OCEAN CITY 29TH STREET FIRE HOUSE ADDENDUM #2 PROJECT 16-35 JULY 18, 2016

29Th STREET FIRE HOUSE REBID

ADDENDUM #2 07-18-16

5 Macarthur Boulevard | Somers Point, NJ 08244 1:609.927.0888 | f: 609.927.0889 www.wmarch.net ^{7/15/16} **S2**

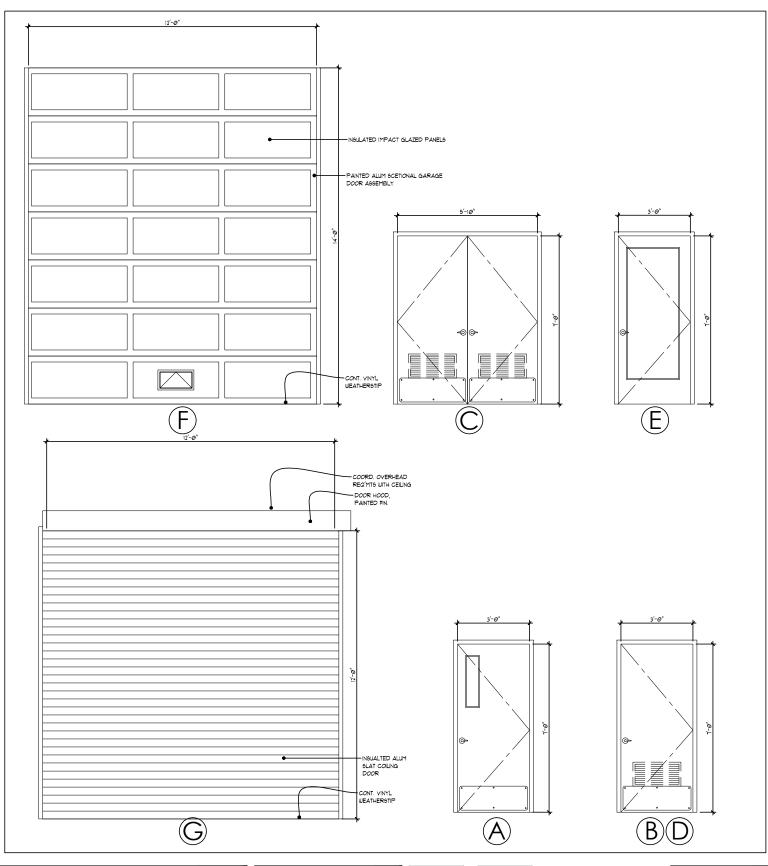
• See attached SK2, dated 07-15-16 for door type clarification(s)

FIRESTATION No. 2 29TH STREET & WEST AVENUE COLUMN ENCLOSURE DETAIL

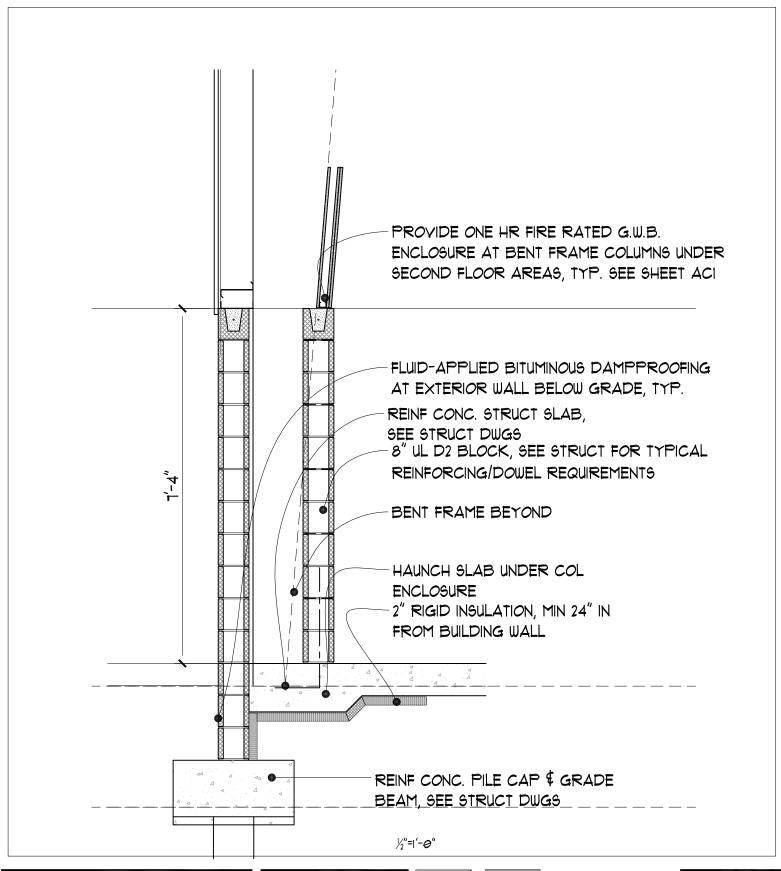
• See attached SK3, dated 07-14-16.
